Technical Memorandum

Date: June 11th, 2010
To: Brian Beyak, P.Eng, Manitoba Hydro
From: Jamie Ellis, P.Eng, AECOM
Project Number: 0217-200-07 (3) [Hydro Ref: 243 981 0100]
Subject: **Keeyask Infrastructure Project – North Access Road Start Up Camp
Design for Wastewater Disposal
Additional Information at June 11th, 2010**

0 0.1 0.2 0.3 m SCALE 1:10

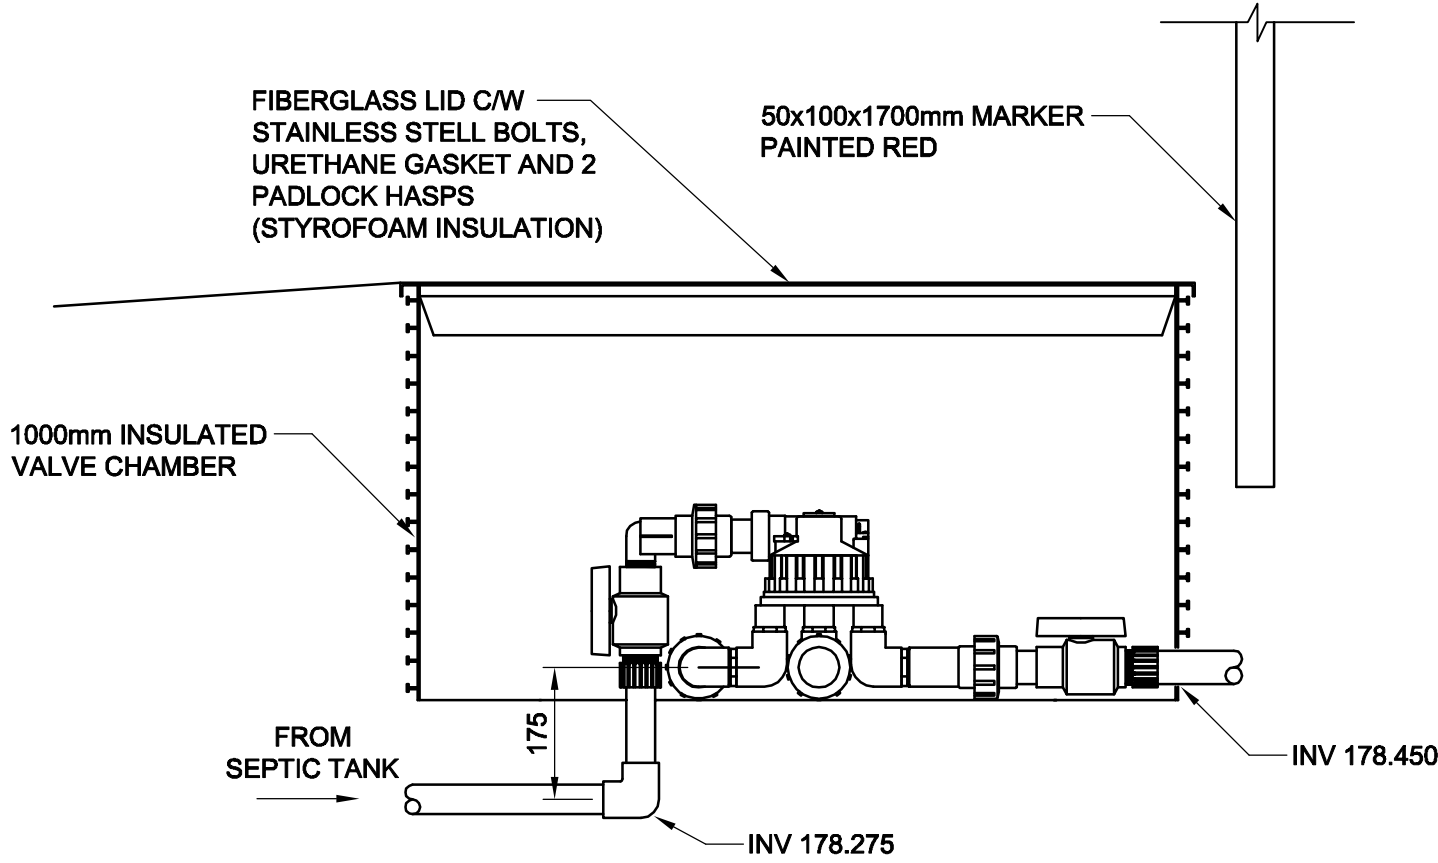
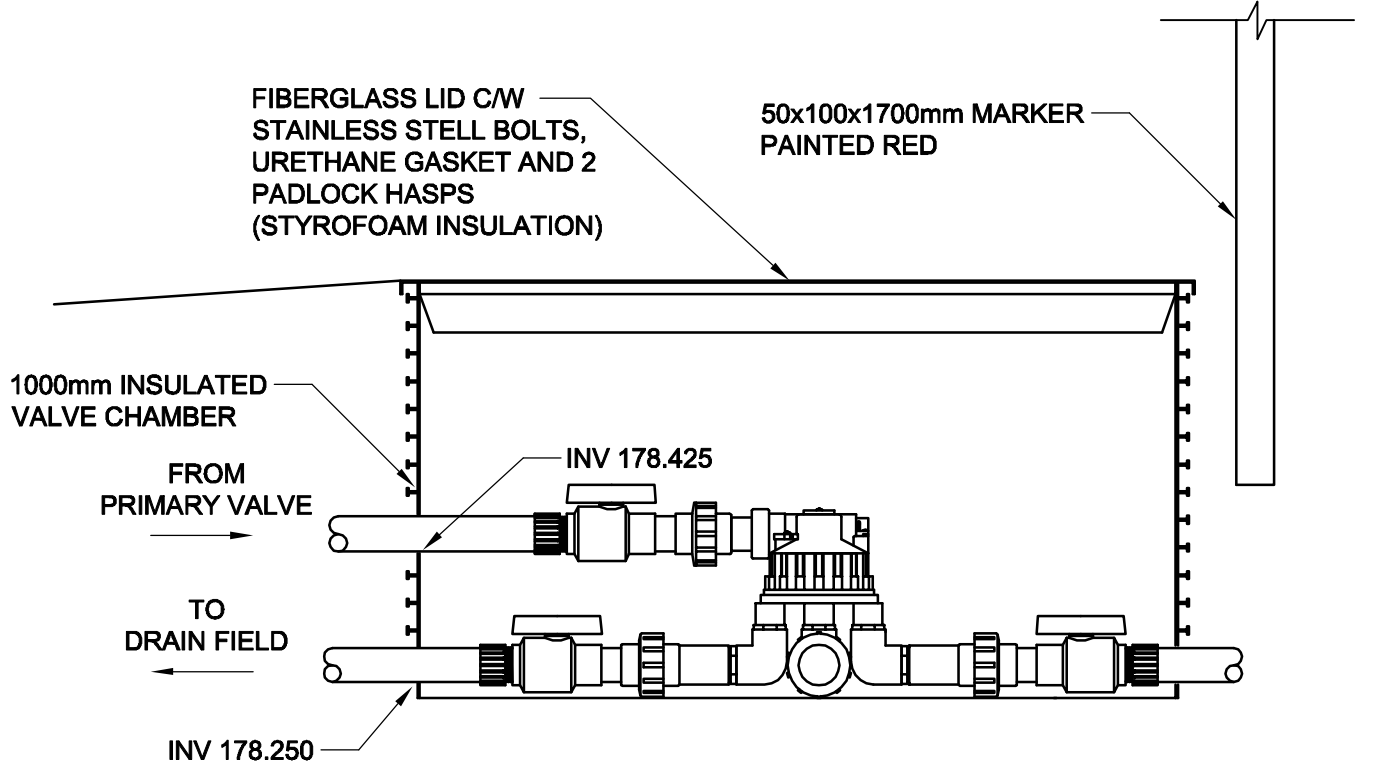
As shown on the drawings, it is proposed that an arrangement of 5 automatic distributing valve assemblies (1 primary and 4 secondary, each mechanically operated) which operate with each pump cycle. As such, flow is sequentially directed to a total of 16 zones across the 4 cells.
